**MAYOR AND CITY COUNCIL OF LAUREL
DEPARTMENT OF ECONOMIC AND COMMUNITY DEVELOPMENT**

TECHNICAL STAFF REPORT

CASE: Amended Site and Landscape Plan Application
13600 Baltimore Ave Suite 600
Laurel, MD 20707

REQUESTED ACTION: Approval of Amended Site and Landscape Plan to make exterior alterations.

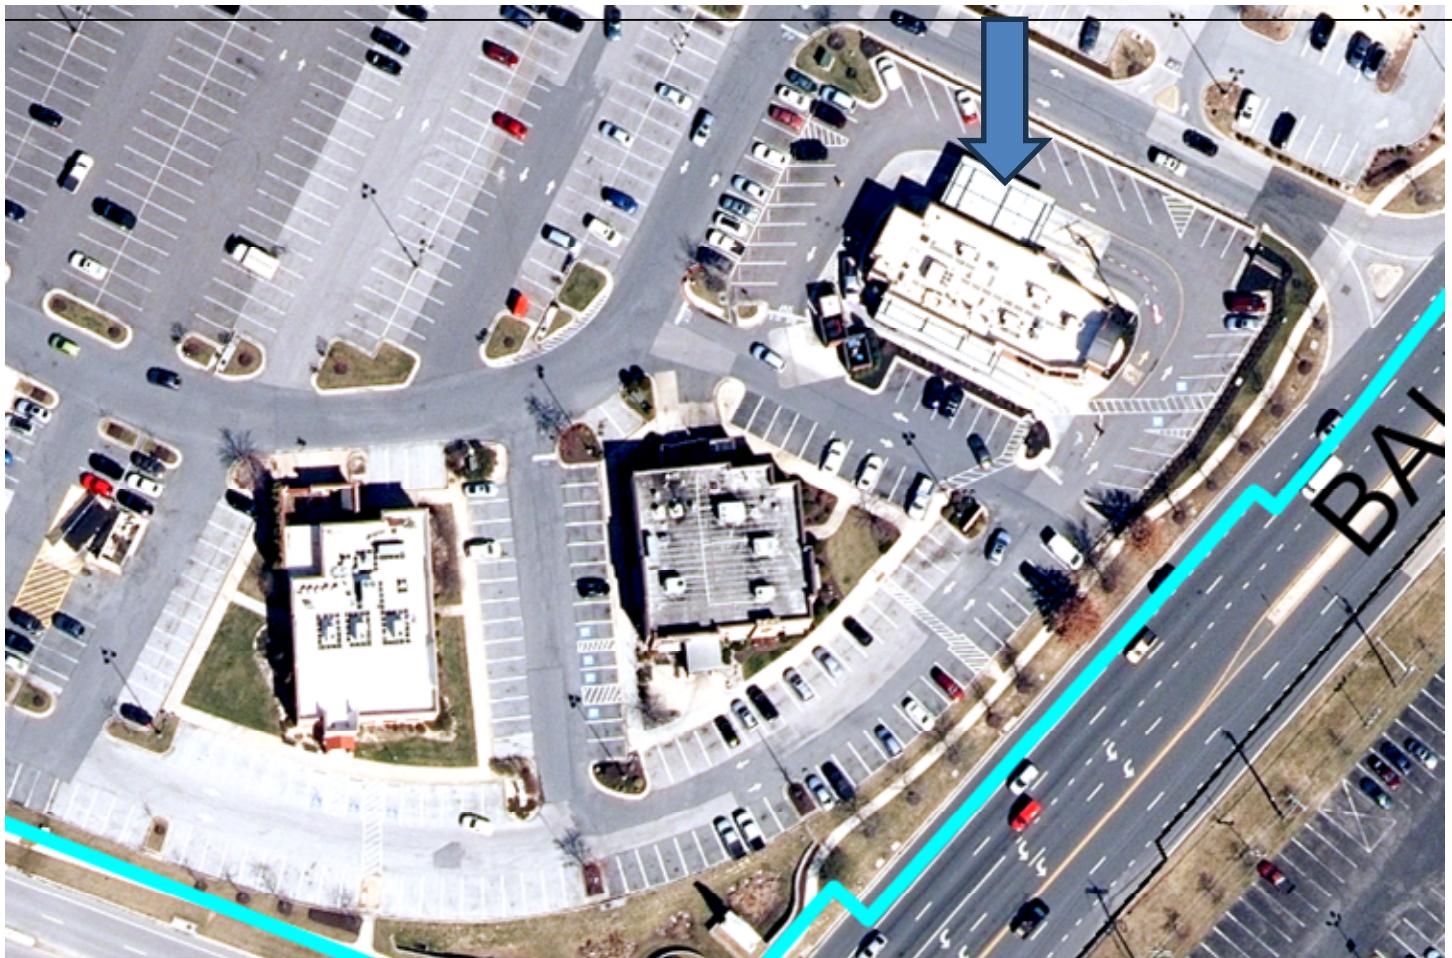
- Recommend the accessory structure be located in the rear of the property to better screen the use and limit sight distance issues at the entrance to the shopping center and Baltimore Avenue.

- We would suggest moving the trash enclosure to the northwest corner of the property where parking would be less likely used given the conflicts with the drive-through. The existing vegetation and green area in this location could also be modified to accommodate the structure and provide additional screening.

- The plans also do not show what will happen to the existing freestanding sign, but if retained this may add to the sight distance concerns. If it is to be reconstructed and the new trash enclosure remains in the current location the sign should be incorporated into the enclosure's design to limit impact.
